Appendix A – Summary of proposed restrictions, objections, letters of support and responses

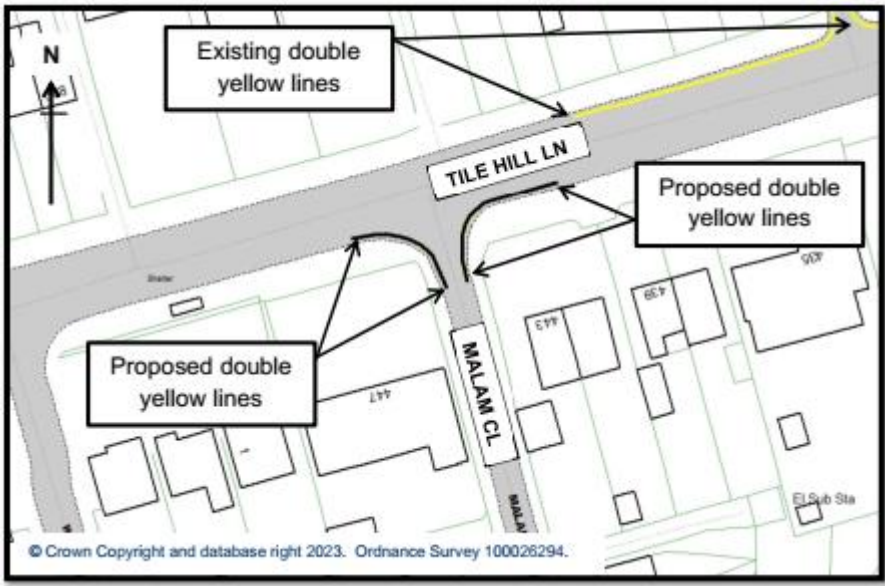
Location (Ward)	Fenside Avenue /Jacquard Close (Cheylesmore)
Original Request	Safety concerns raised by resident due to parking at the junction restricting visibility.
<p>Proposal</p>	<p>Proposed double yellow lines (no waiting at any time) for junction protection.</p>  <p>© Crown Copyright and database right 2023. Ordnance Survey 100026294.</p>
<p>Objections (2)</p>	<p>Summary of points raised:</p> <ul style="list-style-type: none"> • Details provided of where people tend to park and • I am unaware of any accidents in this area • There are no other restricted parking areas in Fenside Avenue at other junctions, save for the garage area (by the shops), and further up by the brook bridge and on the entrance leading in to the avenue by the shops. • The Fenside junctions with Arnold Avenue, Chatsworth Rise and Baginton Road are, in my opinion, having lived here for years, are far busier than the small junction at Jacquard Close. Are these junctions also inline for waiting restrictions? • Where markings have been applied to the carriageway further down Fenside Avenue, the length of marking appears shorter than that proposed outside numbers 23 & 21 Fenside. Why is this so? • As cars rarely park [on the west side of the junction], there is not a problem of cars being parked there to create potential safety issues. I see no need for these restrictions to be implemented <p>Summary of points raised:</p> <p>Restricting the on-street parking [as proposed] means there will be more cars parked on the opposite side, which would add to safety issues for people to walk along the pavement plus cause issues for bin lorries to manoeuvre so that they can collect bins from Jacquard Close and Fenside Avenue (for no. 25,27,29,31). It does not matter if cars are parked [where double yellows are proposed] if someone is parked on the opposite side, they will obstruct the larger vehicles including bin lorries and buses. We have had several occasions when bin lorries have been unable to collect bins due to cars being parked on the opposite side to our house.</p> <p>If the double-yellow lines are installed it would also cause safety concerns when cars are coming in and out of Jacquard Close due to more cars being on the opposite side.</p>

<p>Reference to personal parking situation and resultant effects of where park</p> <p>We have been living at our property for [number of years] without any parking safety concerns raised (both on Fenside Avenue and Jacquard Close). Recently, over the last 6 months to a year we have had speeding drivers and motorbike riders going along Fenside Avenue and that is the main safety issues here and not the concerns about parking as the speeding drivers/riders drive/ride at excessive speeds regardless of whether there are cars parked on either side or not. The speeding is a bigger concern as we have elderly and young children using the pavements and roads.</p> <p>Raises issue of speed of drivers existing Jacquard Close</p> <p>Proposals are grossly unfair. I think it is potentially the speeding drivers that are the ones complaining as they are the ones that want to drive and ride along our streets using excessive speeds.</p> <p>Recommend rather than double yellow lines we have speed bumps installed along Fenside Avenue, as the main safety issue here is speeding and not the parking of our cars on our side of the street.</p> <p>An alternative measure could also be that double-yellow lines be placed on the opposite side of the road as this would allow traffic to move smoother and larger vehicles would have better access along Fenside Avenue and Jacquard Close.</p>

Support (1)	<p>Have wanted double yellow lines for years. [We] feel that the lines should be put in opposite the junction with jacquard close as well, due to people parking opposite the junction which also causes problems for residents & the refuse crews alike, not only for access but for safety.</p> <p>The situation is getting extremely dangerous with cars having to go into the middle of Fenside Ave when leaving Jacquard to see if the way is clear. The bin lorries have had problems, having to mount the pavement in order to gain access to Jacquard, also a few months ago an ambulance had problems</p>

Response to objection	<p>The Highway Code (243) states 'Do not stop or park opposite or within 10 metres (32 feet) of a junction, except in an authorised parking space'. This is to provide visibility at a junction. The proposed double yellow lines are in accordance with this advice.</p> <p>At the time of a site visit road was heavily parked in this area, both up to the junction and opposite.</p> <p>Recommendation – Install as proposed and monitor.</p>

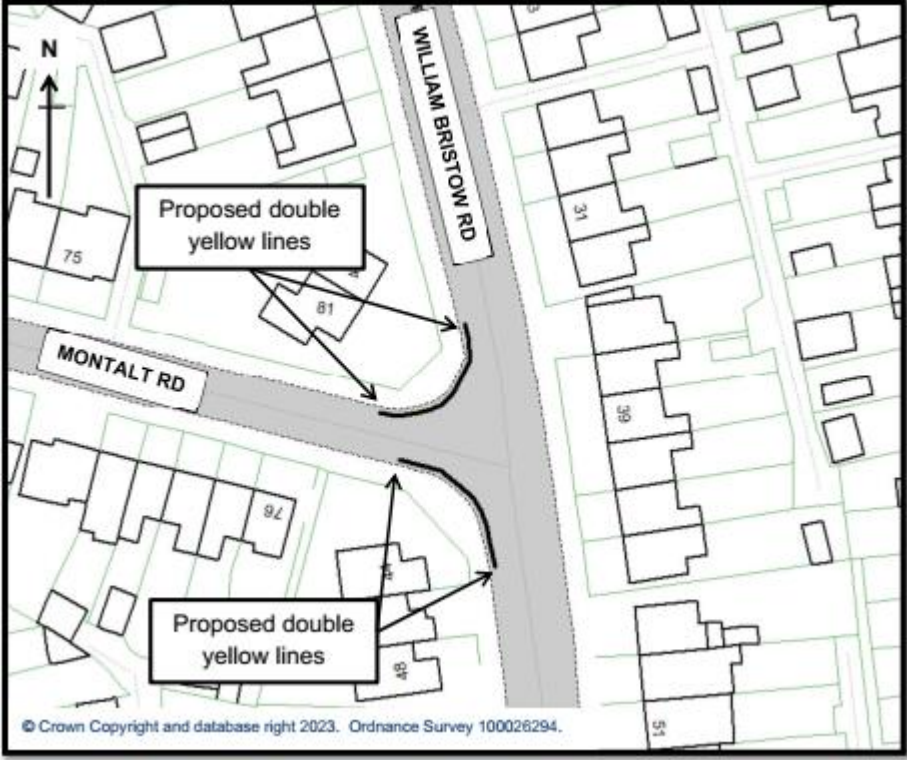
Location (Ward)	Gardenia Drive (Bablake)
Original Request	117 signature petition, sponsored by Councillor Birdi, requesting parking restrictions to prevent all day parking and improve the turnover of available parking space.
Proposal	<p>Proposed limited waiting restriction in layby outside shops (everyday, 8am-6pm. 1 hour no return in 2 hours).</p>  <p>© Crown Copyright and database right 2023. Ordnance Survey 100026294.</p>
Objection (1)	<p>I understand that there is a proposed 1 hour timed parking restriction in the layby alongside the Hairdresser's, Beauty Salon and Cafe in Gardenia Drive and I lodge an objection to the proposal.</p> <p>A timed parking restriction of only 1 hour does not allow for some procedures at the Hairdresser's and Beauty Salon whereas if it were extended to 2 hours this would be more realistic and would not present a problem or loss of clients to those businesses. Therefore please amend the proposal to 2 hours restriction.</p>

Response to objections	<p>The proposed limited waiting restriction was to create a turnover of spaces. To amend the restriction to allow a longer time to park, increasing from 1 hour to 2 hours, would be a significant change to the proposal. Therefore, it is not possible to do this as part of this TRO process. The proposals would be required to be advertised again, with the associated 21 day objection period.</p> <p>Options:</p> <ul style="list-style-type: none"> Do not install the 1 hour limited waiting restriction and advertise a new proposal for a 2 hour restriction as part of the next waiting restriction review. Install the restriction as advertised (1 hour limited waiting), monitor and consider amending the duration of stay as part of a future waiting restriction review. <p>As the objector is identifying that the 1 hour restriction would not be beneficial and may adversely affect the businesses, it is recommended that the 1 hour restriction is not installed and a 2 hour limited waiting restriction is advertised as part of the next waiting restriction review.</p> <p>Recommendation – Remove the proposed 1 hour limited waiting restriction from the TRO process and advertise an alternative proposal (2 hours limited waiting) as part of the next waiting restriction review.</p>

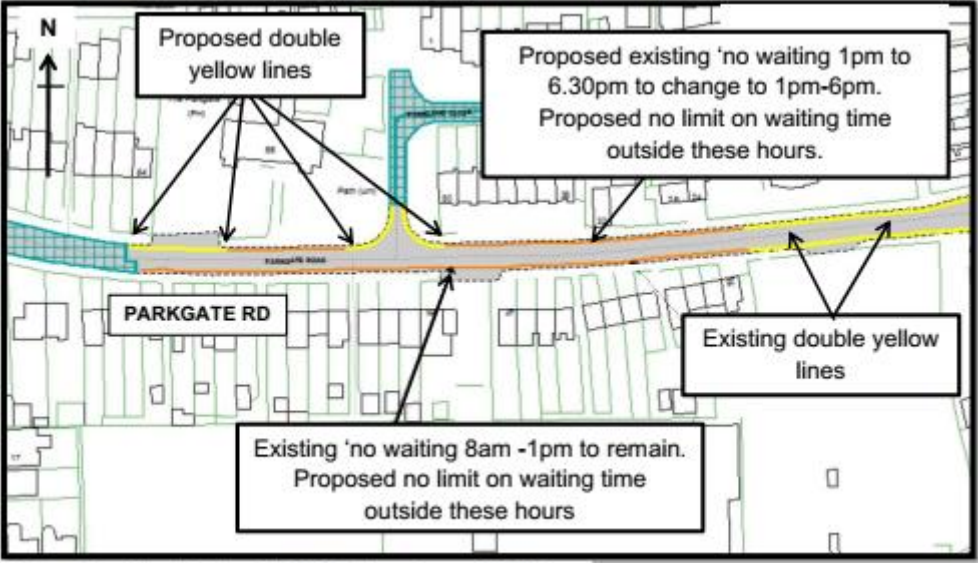
Location (Ward)	Lollard Croft (Cheylesmore)	
Original Request	Resident raised access concerns due to parked vehicles on narrow section of road	
Proposal	<p>Proposed to extend existing double yellow lines (no waiting at any time) a further 23m into Lollard Croft</p>  <p>© Crown Copyright and database right 2023. Ordnance Survey 100026294.</p>	
	Due to the number of objections received (3) with similar reasons, the objections have been grouped together highlighting the main reasons for objecting to the proposals. Due to the detailed nature of some objections they have been forwarded in full to the Cabinet Member.	
Objections (3)	The following are the issues raised in the objections. The number relates to the number of objections which have raised the same or a similar issue.	
	Concern about available parking (due to residents' parking schemes in the surrounding area, which may be increasing)	3
	Conscious of a small number of occasions when vehicles have unwittingly parked in an inconvenient location and caused temporary access issues [into particular property]. Inconsiderate parking is not an issue.	1

Response to objections	<p>The extension of the double yellow lines on Lollard Croft is proposed on the narrow section of the road, which is only approximately 3m wide, where issues have been raised about access.</p> <p>A query has been raised, via the objections, as to why the proposed double yellow lines are necessary, as parking, so as not to cause an obstruction, is covered by the Highway Code.</p> <p>The Highway Code is guidance; if a vehicle is parked in a manner that is causing a danger or obstruction the Police have the necessary powers to undertake enforcement action, without the need for waiting restrictions. However, they have limited resources. Coventry City</p>

<p>Council and many other Councils have powers which enable Civil Enforcement Officers to undertake enforcement of waiting restrictions. This is to improve traffic management, both in terms of safety and movement of traffic.</p> <p>Residents of Lollard Croft have previously been consulted about the possibility of being part of a wider residents' parking scheme. However, one criterion to be part of a scheme is that 60% of households must be in favour; this was not achieved. In response to a petition, a further consultation about the possibility of being part of the wider residents' parking scheme will be undertaken.</p> <p>In response to the objections received it is proposed to reduce the extent of the proposed double yellow lines by approx. 5m on each side of the road and monitor.</p> <p>Recommendation – Install a reduced extent of double yellow lines, reducing the proposal by 5m (each side of the road)</p>
